South Texas Project
Units 3 and 4
Docket Nos. 52-012 and 52-013
Response to Requests for Additional Information

Attached are Nuclear Innovation North America LLC (NINA) responses to staff questions in Request for Additional Information (RAI) letter number 415 and a revised response related to Combined License Application (COLA) Part 2, Tier 2, Section 9.1, "Fuel Storage and Handling." The attachments to this letter include non-proprietary responses (Attachments 1, 2 and 3) and proprietary responses (Attachments 5, 6 and 7) to the following RAIs:

RAI 09.01.02-9

RAI 09.01.02-17**QUESTION:**

Figure 7: Original Acceleration Time History – X Direction (Horizontal)

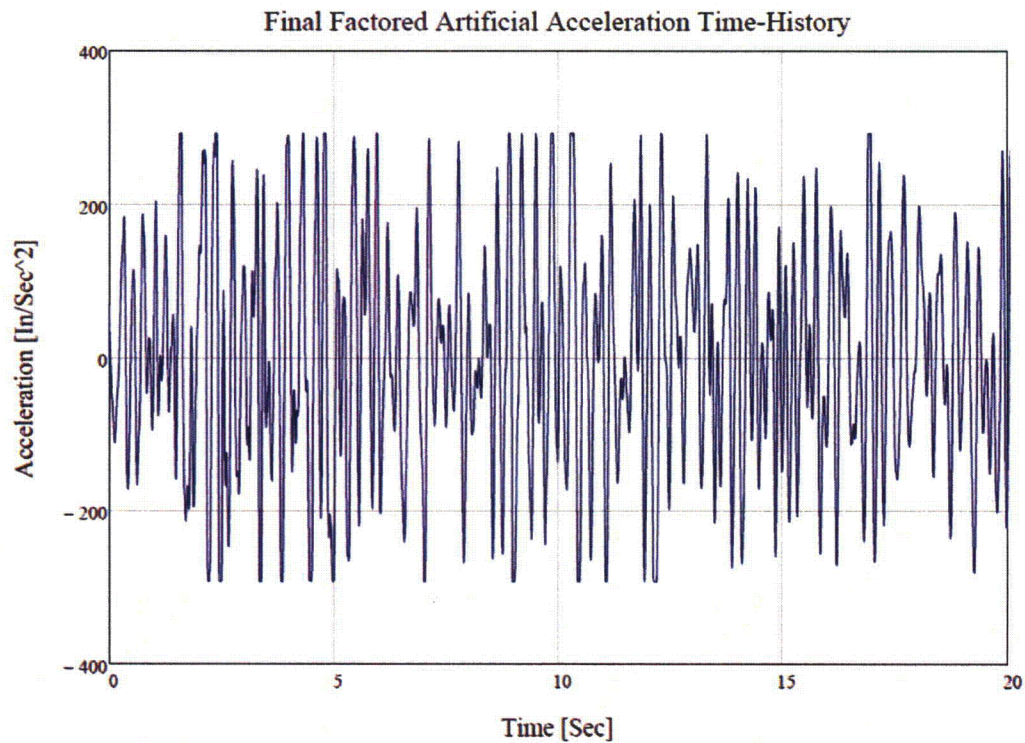
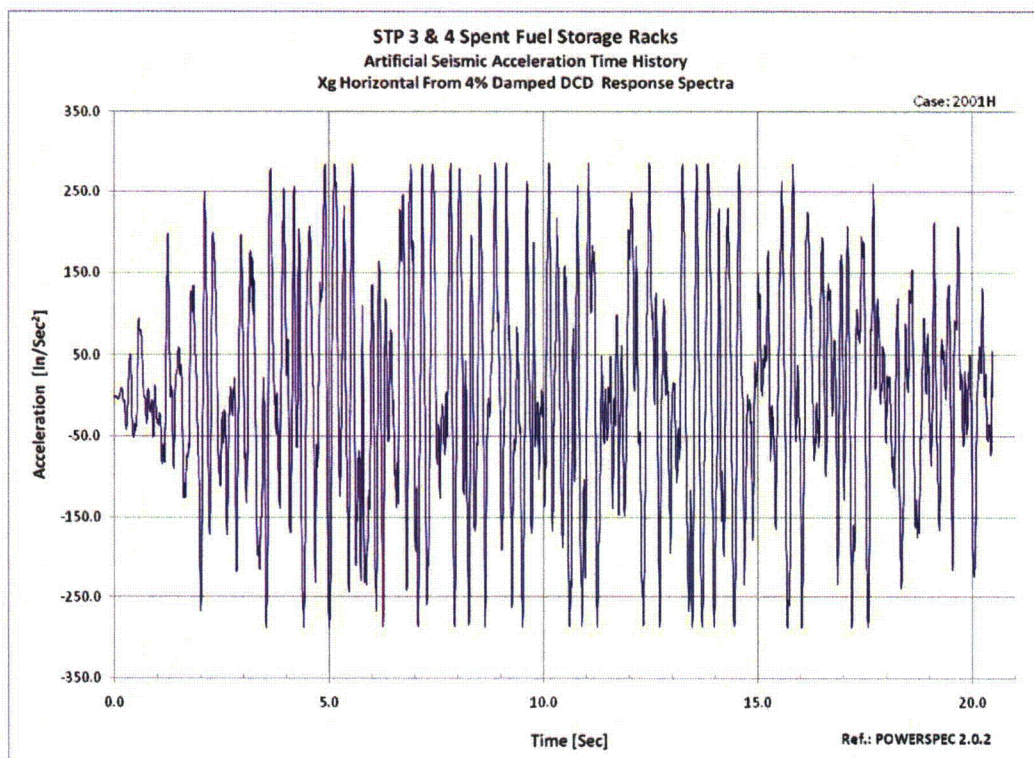
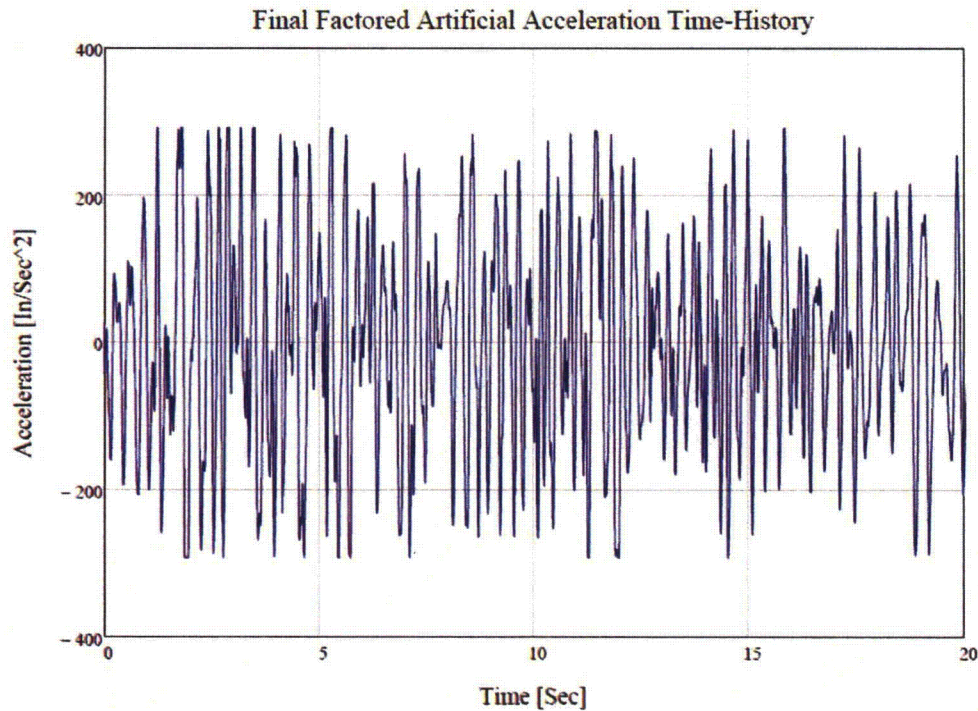
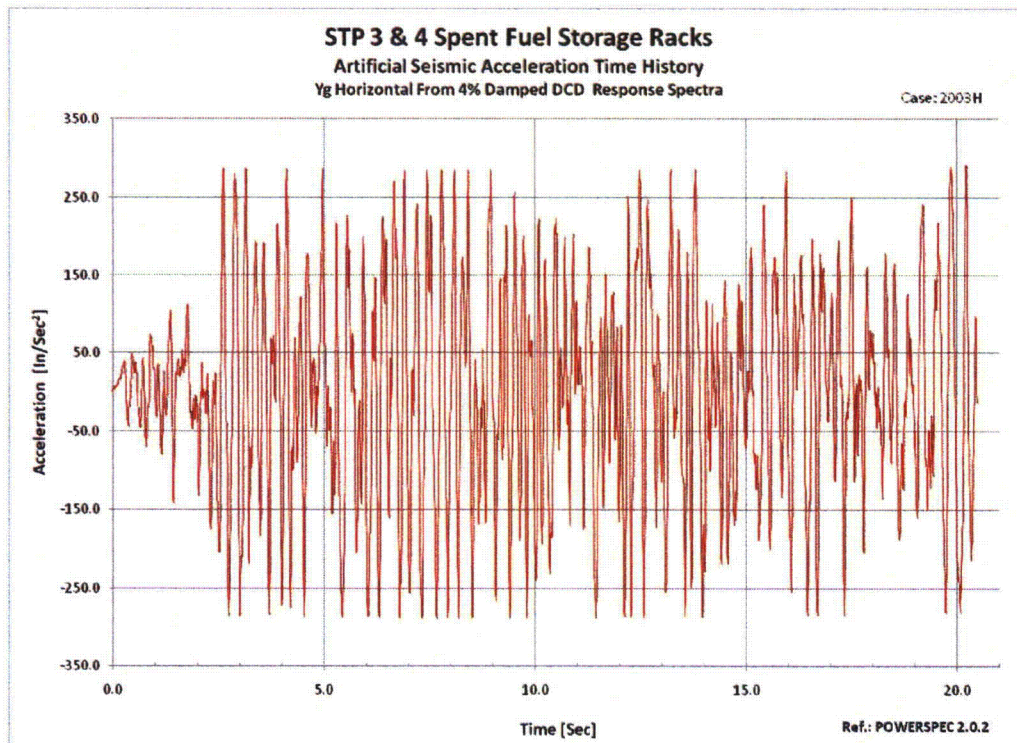
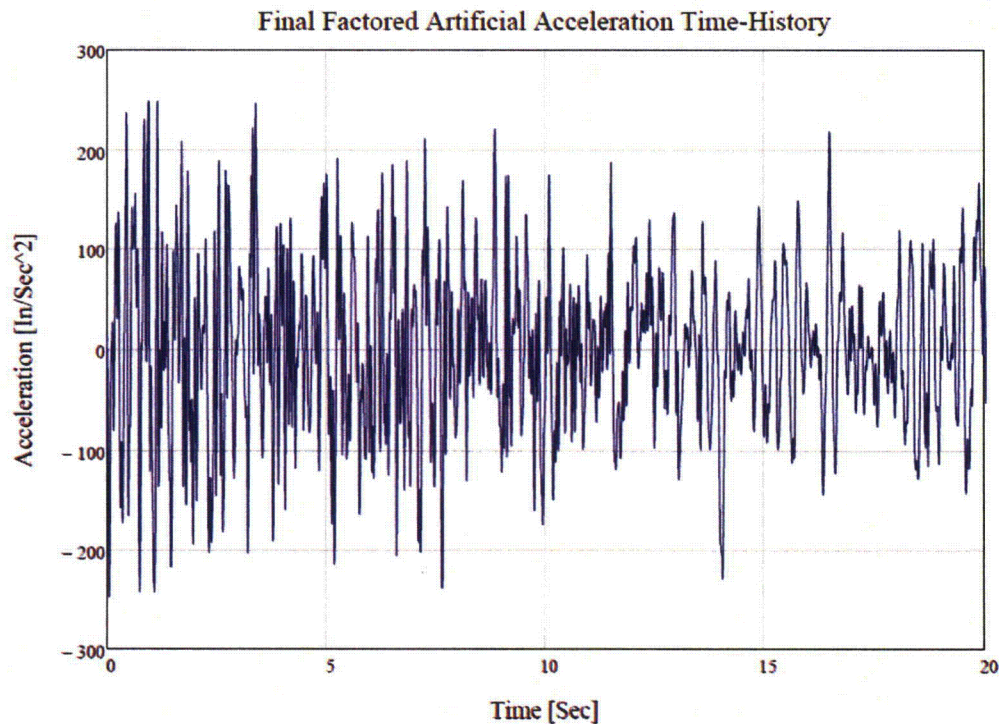
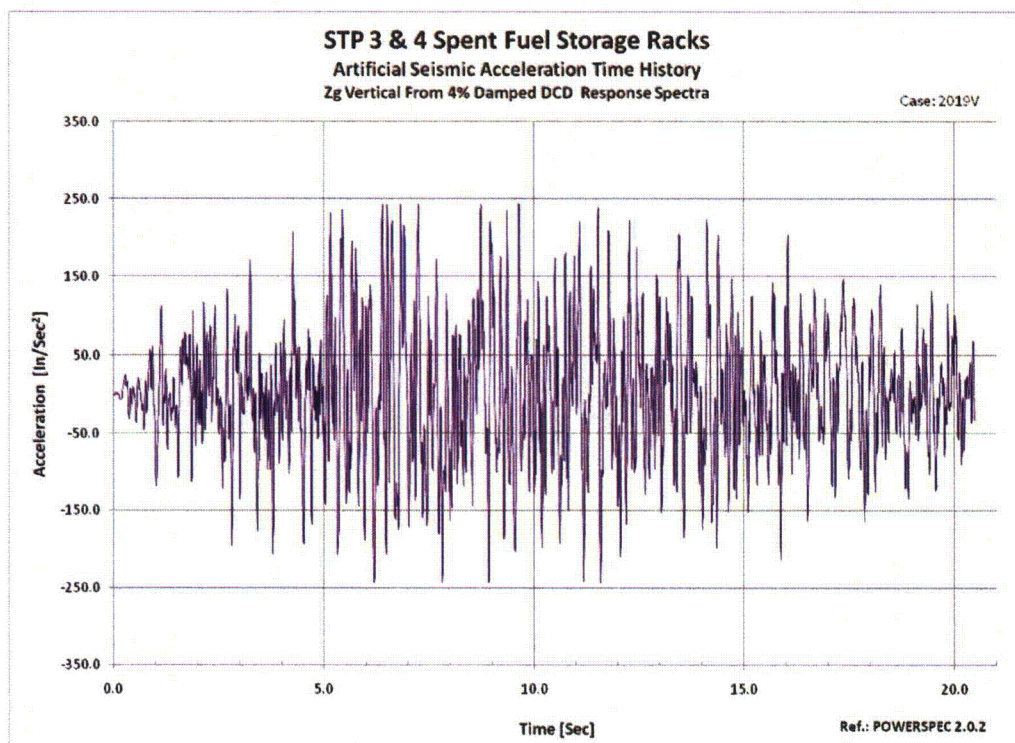
- d. The plots of the horizontal synthetic time histories presented in Figures 4-2 and 4-3 of the Technical Report exhibit the characteristic that there are many acceleration peaks up to the target spectrum ZPA. It appears that these time histories are derived from traces that had higher acceleration peaks, and all the higher peaks were reduced to the ZPA. Consequently, the synthetic time histories do not look like earthquake time traces. Please explain the process used to develop the horizontal synthetic time histories, and provide the technical basis for their adequacy.

The process used to generate the artificial time histories is the same process used by Westinghouse to generate artificial time histories for the AP1000® PWR spent fuel rack licensing effort. This approach yielded results that meet the requirements of NUREG-0800, SRP 3.7.1 as described in the response to c. above. The methodology uses a MathCAD spreadsheet to perform an iterative calculation, which converts a starting recorded earthquake ground motion, in this case the El Centro earthquake, to a time history with a calculated response spectrum that closely matches the target input seismic response spectrum. If, during an iteration, the acceleration exceeds the specified Zero Period Acceleration (ZPA), the worksheet automatically lowers the value to the ZPA (also known as “clipping”). This is a standard part of the methodology, and results in synthetic time histories that closely match the target response spectra. The resulting time histories (design-basis time histories) are used in the design and analysis of the spent fuel racks.

As part of the response to the RAI, Westinghouse created a second set of artificial time histories, using an alternative method, for the sole purpose of confirming the adequacy of the original time histories used in the fuel rack analysis. The alternative method of producing artificial acceleration time histories is a mathematical approach of overlapping sine waves. This approach is available in PowerSpec 2.0.2 software. This software tool provides limited control of the ramp in and out of the strong motion portion of the event; however, there is less control over the matching of the calculated response spectrum (therefore, results may include overly conservative peaks in acceleration at any number of frequency points within the spectrum). A number of test cases were evaluated. These curves did have the classic appearance (i.e., ramp in and ramp out) and did not require “clipping” to maintain ZPA. Two successive integrations of the artificial acceleration time histories produce velocity and displacement time histories that did not exhibit “drift” and therefore does not require baseline or “drift” correction. This alternate method produced very similar results compared to the first (MathCAD) method. A comparison of acceleration time history results are included in Figures 7 through 12. For additional comparison, as further discussed in part f., a single rack model was run, with input generated from both the design-basis time histories and the second set of time histories. These results are also very similar, which confirms the adequacy of the design-basis time histories.

In summary, the design-basis time histories were created using the same methodology as that accepted for the AP1000® PWR spent fuel rack seismic analysis, and they satisfy the acceptance criteria as provided in NUREG-0800, SRP 3.7.1. To confirm these original time histories, a second set of time histories was created using an alternative method. The second set of time histories closely matches the originals, and test runs using input from both time histories provide similar results. Therefore, the design-basis time histories are confirmed to be acceptable.
